Access Compliance Report

Public Rights-of-Way

Intersection ID: 45835	Main Street: CHRISTENBURY_HILLS_LN	Cross Street: KELDEN_WALKER_LN	Location: SW
ADA ID: FCC132DFEDE3	Ramp Type: Perp	Initial Pass/Fail: Fail	Overall Compliance: No
Severity Score: 58.75			
Codes/Mitigation Info/Possible Solution		Field Measurements/Component Compliance

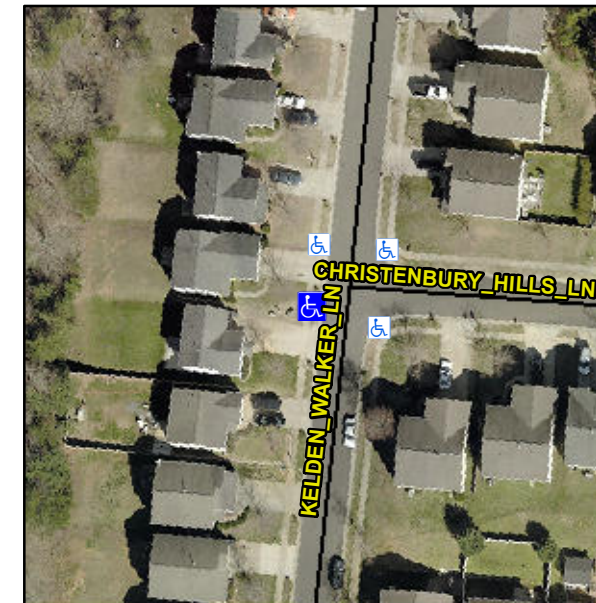
Not Found, R304.5.1, R304.2.2, R304.5.3

Compliance	Description	Data	Compliance	Description	Data
N/A	Ramp Length (in)	46.5	No	Ramp Slope (%)	15.6
No	Ramp Width (in)	47.5	No	Ramp XSlope (%)	10.3
N/A	Flare Type LT	N/A	N/A	Flare Type RT	N/A
N/A	Flare Slope LT (%)	N/A	N/A	Flare Slope RT (%)	N/A
N/A	Flare Traversable LT?	N/A	N/A	Flare Traversable RT?	N/A
N/A	Landing Length (in)	N/A	N/A	DWS Provided?	N/A
N/A	Landing Width (in)	N/A	N/A	DWS Contrast?	N/A
N/A	Landing Slope (%)	N/A	N/A	DWS Length (in)	N/A
N/A	Landing X Slope (%)	N/A	N/A	DWS Full Width?	N/A
N/A	Landing Curb? (Y/N)	N/A	N/A	DWS Offset (in)	N/A
N/A	Shared Landing?	N/A			
N/A	Gutter Ponding?	N/A	N/A	Gutter Slope (%)	N/A
N/A	Gutter Lip Ht (in)	N/A	N/A	Gutter X Slope (%)	N/A
N/A	Painted X Walk1?	No	N/A	Painted X Walk2?	N/A
	X Walk 1 Direction	To SE		X Walk 2 Direction	N/A
N/A	X Walk 1 Width (in)	N/A	N/A	X Walk 2 Width (in)	N/A
	X Walk 1 Slope (%)	3.4		X Walk 2 Slope (%)	N/A
	X Walk 1 X Slope (%)	9.7		X Walk 2 X Slope (%)	N/A

Remove & Replace Entire Ramp.
